**RESOLUTION HOLDING HEARING ON REQUEST FROM JJ EQUITY, LLC TO REZONE PROPERTY LOCATED AT 3300 EAST 56<sup>TH</sup> STREET FROM “A-1” AGRICULTURAL DISTRICT TO “PUD” PLANNED UNIT DEVELOPMENT DISTRICT**

RE: Brook Landing PUD Rezoning

# BROOK LANDING

**BROOK LANDING**  
**PUD CONCEPTUAL PLAN**

Condition 18: 70' wide lots in phases 5 & 6

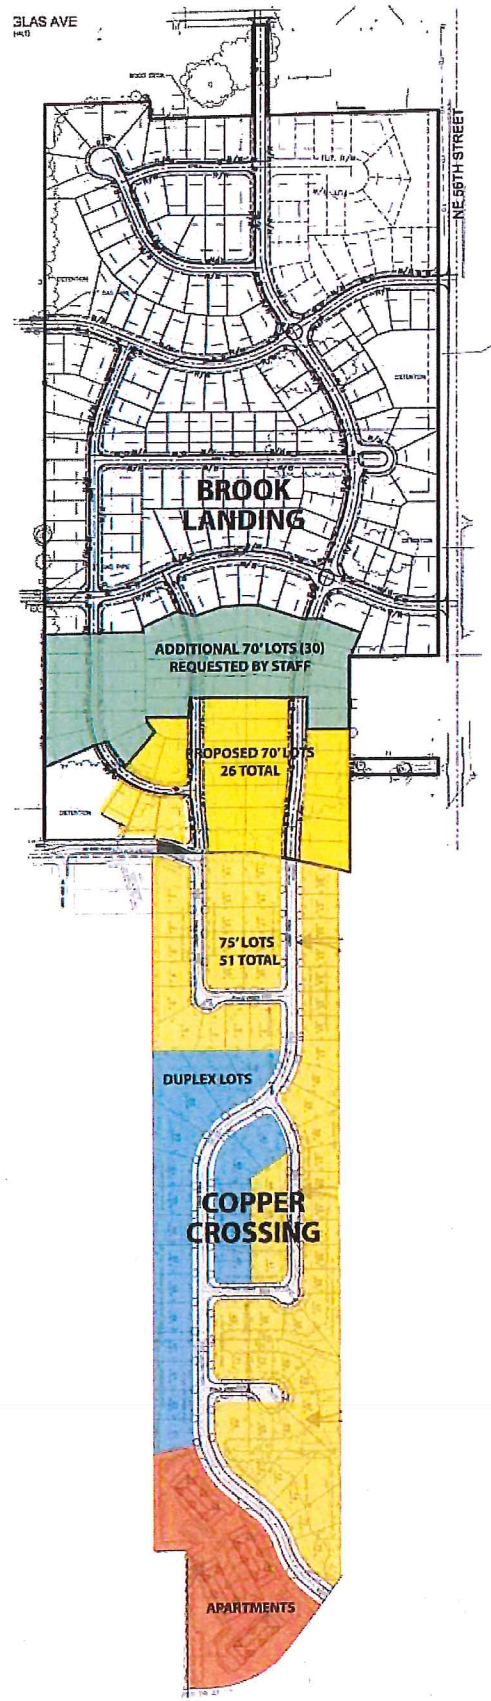
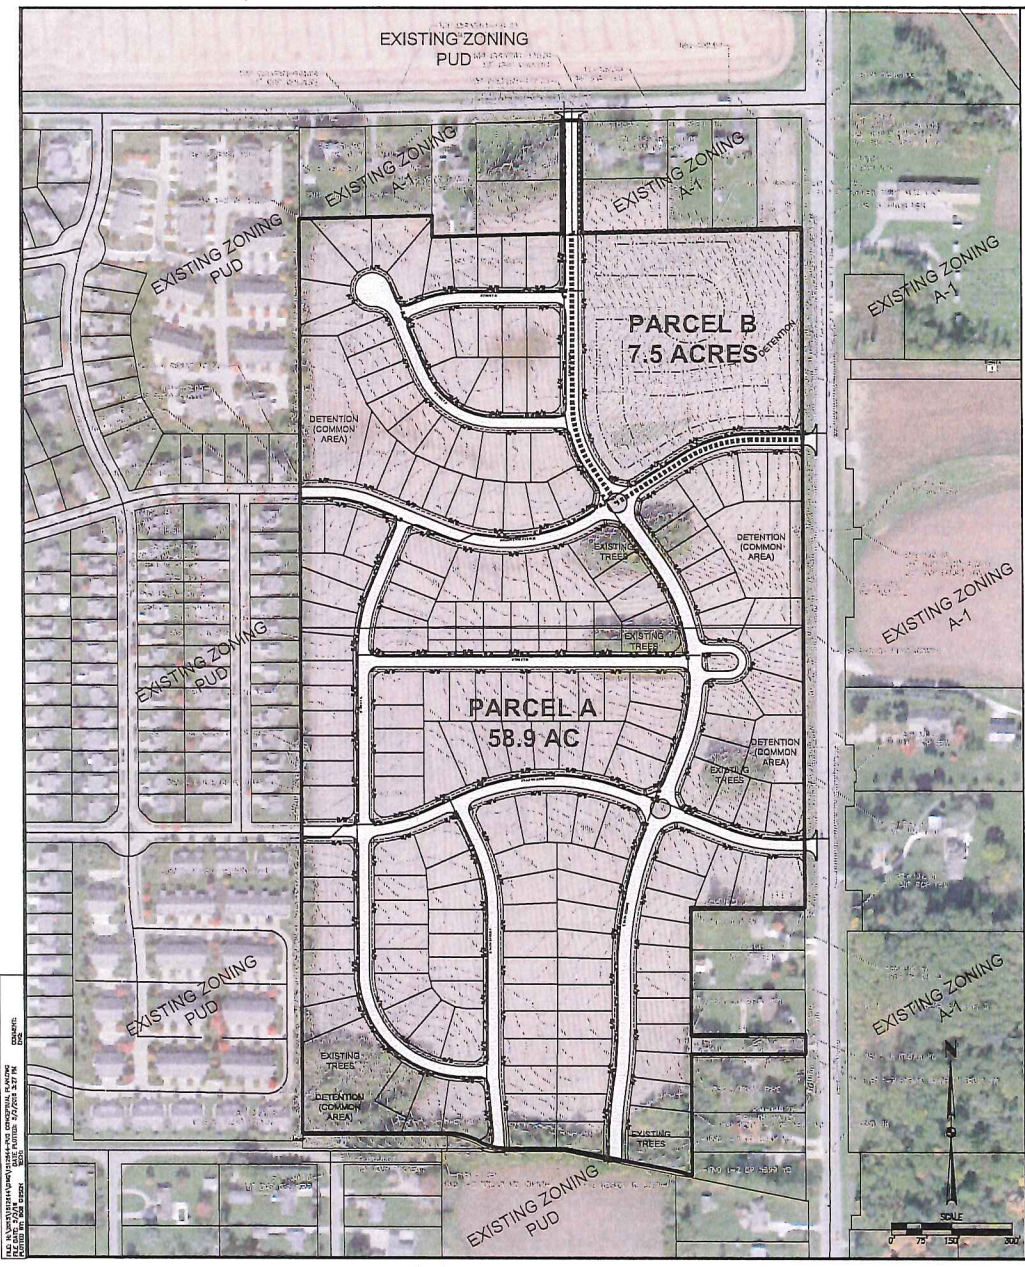
We are requesting that Council reconsider items 17 and 18 of P & Z's recommended conditions.

Condition 17: Side yard setbacks

We are requesting 5' side yard setbacks instead of R1-60 7' minimum/15' total.

- The single family lots immediately to the west in Brook Run are 50' – 57' wide with 5' side setbacks and 20' front setbacks. Brook Landing lots are a minimum of 60' wide with a front setback of 30' for the house and garage, 25' for a porch.
- The reduced setback allows for flexibility and the most efficient use of the lot, as the side yards are nonfunctional areas, and most floor plans minimize, if not eliminate, windows on the sides.
- The reduced setback will allow a 3 car garage option and larger, nicer homes resulting in a greater overall tax base in the area.

Staff has requested this to act as a transition to the approved, but not constructed Copper Crossing PUD to the south.

- We understand the desire for transition, but this requirement is excessive. It is asking that 56 lots provide a transition for 51 lots that themselves are adjacent to duplex lots and an apartment lot. See the attached sketch.
- With the reconfiguration of Brook Landing streets (Item #6) we have provided 26 lots at 70' wide. This is certainly an adequate transition.
